00-DOE-03378

Enclosed please find minor modification #5 to the final Building 776/777 Decommissioning Operations Plan (DOP). This minor modification is being submitted in accordance with Section 4.5.2 of the DOP and Paragraph 127 of the Rocky Flats Cleanup Agreement (RFCA). The modification includes:

Requested Changes to Building 776/777 DOP

Appendix H
B776/777 Closure Project
RCRA Unit Closure Information Sheet

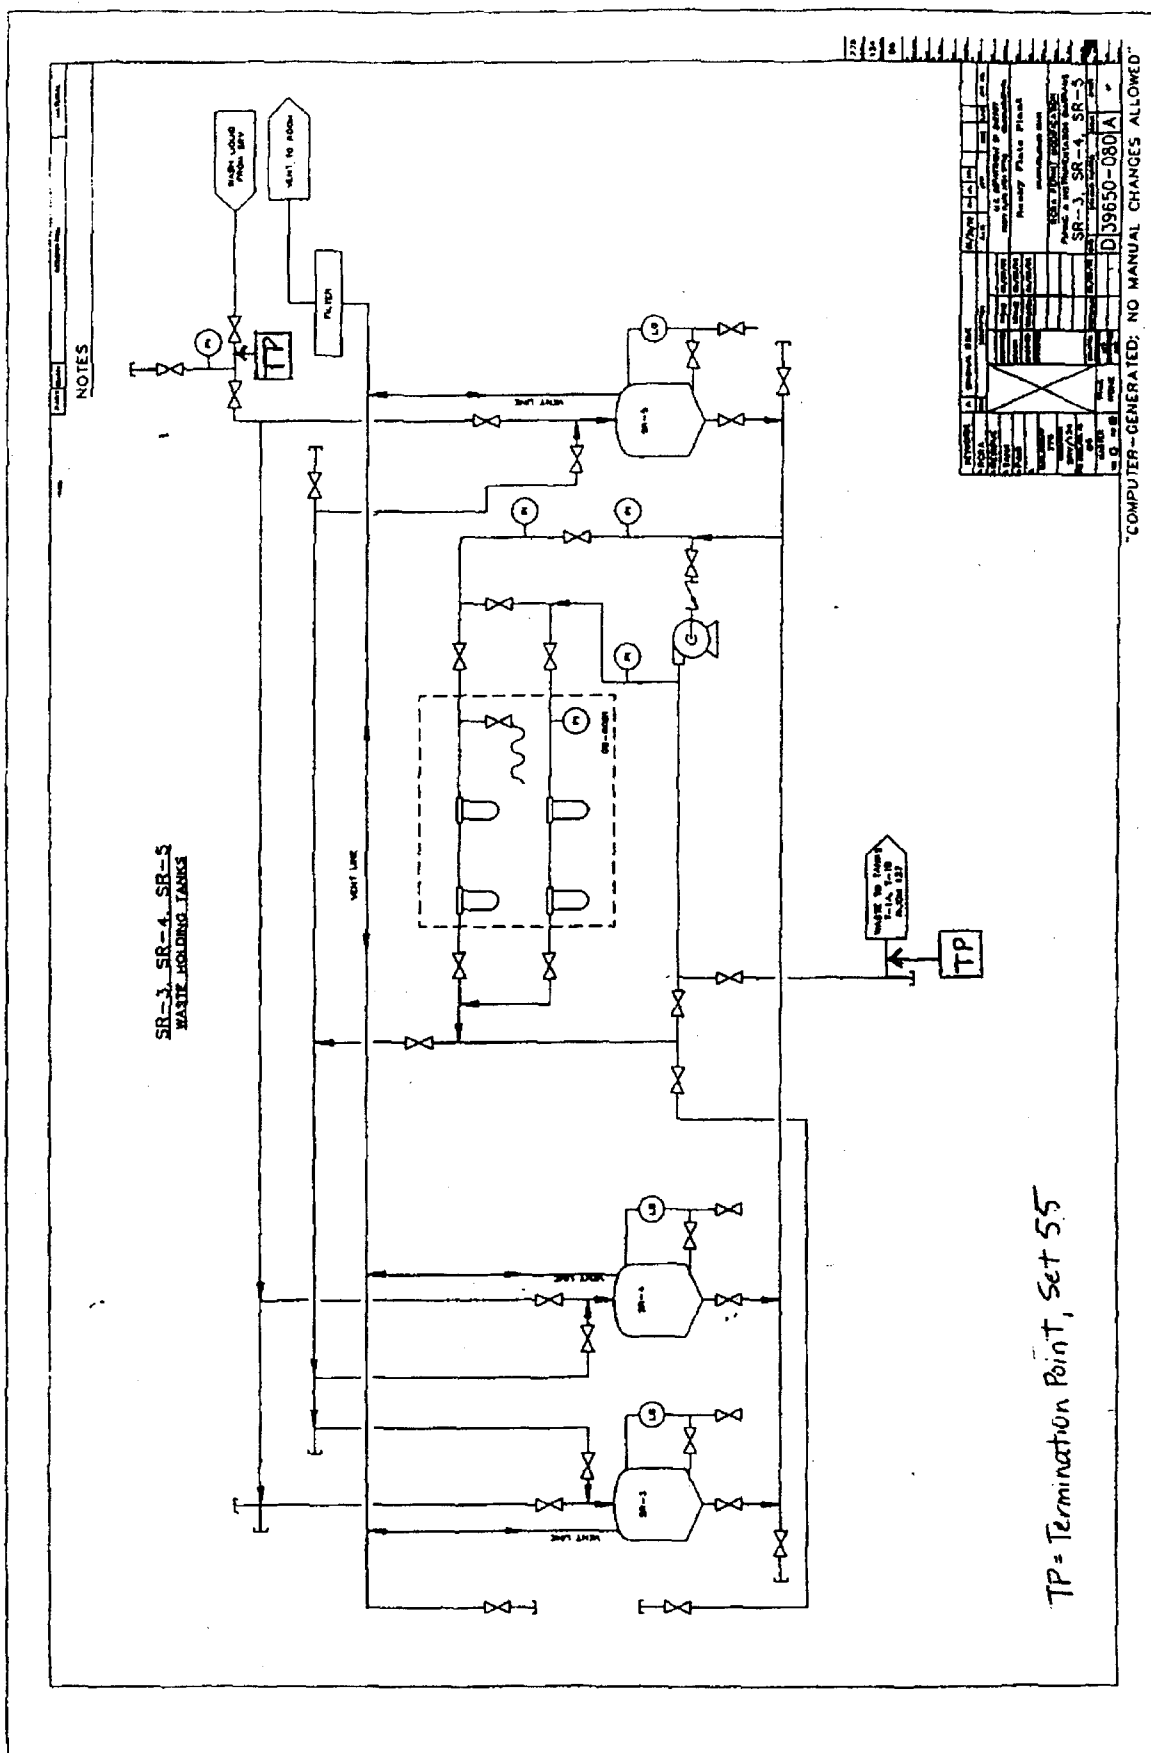
- 2) Appendix H, RCRA Unit-Specific Closure Information Sheets: Please add the attached closure information sheet and drawing for tanks in work set 55.

Unit Description:	<p>Tanks SRV-3, SRV-4, and SRV-5 (RCRA Units 94.001, 94.002, and 94.003) are raschig ring filled tanks located in Room 134 in Building 776. SRV-3 is 53.5" in diameter by 39.5" high, SRV-4 is 41" in diameter and 40.5" high, and SRV-5 is 42" in diameter by 40.5" high.</p> <p>The three tanks were used to collect wash water generated in the Size Reduction Vault (SRV). The wash water was generated from washing leaded acid-contaminated gloves, filters, and metal tooling in the ball mill washer (RCRA Unit 94.009). Wash water from the SRV was pumped through Ful-flo filters in the vault and transferred to Tanks SRV-3, 4, and 5. From these three tanks the waste was filtered in glovebox GB0001 prior to transfer to Tanks T-1A and T-1B in Room 127 (RCRA Unit 776.2). The SRV tanks have been out of service since 1989. The attached drawing shows a schematic of the tank and ancillary equipment with termination points shown for SET 55.</p> <p>The Building 776/777 Reconnaissance Level Characterization Report says the SRV tanks were brought into the building after the 1969 fire for use in the cleanup operations. The tanks were used to collect water from paint removal and other decontamination efforts. Based on the property inventory numbers, these tanks originally came from Building 881, but there is no indication what they were used for there.</p>

Unit Boundaries and Interfaces:	<p>SET 55 includes Tanks SRV-3, 4, and 5 and ancillary equipment in Rooms 134 and 154. Associated ancillary equipment includes inlet piping coming from the SRV (SET 60, Room 146), filters and piping in glovebox GB-0001, recirculation piping and a pump between the tanks and glovebox, and outlet piping leading to Tanks T-1A and T-1B in Room 127 (SET 69, RCRA Unit 776.2). Secondary containment is provided by GB-0001 and the concrete floor.</p>
EPA Waste Codes/ Waste Characterization:	<p>The tank system collected wash water from the ball mill washer in the SRV, which has been characterized based on process knowledge with EPA waste code D008. (Ref. Backlog Waste Recharacterization, Subpopulation 46B, for SRV ball mill sludge, IDC 340.) Any remaining liquid will be drained from the tanks and piping during deactivation, and sample results from the liquid may be used to determine additional waste codes that may be applicable.</p> <p>The piping and tanks will be characterized in accordance with 6 CCR 1007-3 Part 262.11, and managed accordingly.</p>

Closure Activities:	The tank inlet and outlet piping will be removed to approximately the eight-foot level under a work package for SET 55 deactivation and decommissioning. Raschig rings will be removed from the tanks during deactivation. The tanks and glovebox will be removed under a later work package for SET 55 decommissioning. The remainder of the piping will be removed as part of SET 78 (miscellaneous piping over eight feet), and the concrete secondary containment area will be addressed with SET 82 (building structure).
Waste Disposal:	<p>The tanks, piping, raschig rings, glovebox, and secondary waste (e.g., PPE and plastic containment material) generated during closure activities will be managed as CERCLA remediation waste. Liquid hazardous wastes will be managed as RCRA-regulated wastes. Absorbent will be added to waste packages with items that could contain residual liquids or sludges.</p> <p>Upon final radiological characterization, the waste will be packaged to meet the waste acceptance criteria (WAC) of the approved disposal facility. In the event this waste cannot be shipped directly to the approved disposal facility, it will be stored in an approved on-site storage area until shipment can be scheduled.</p>
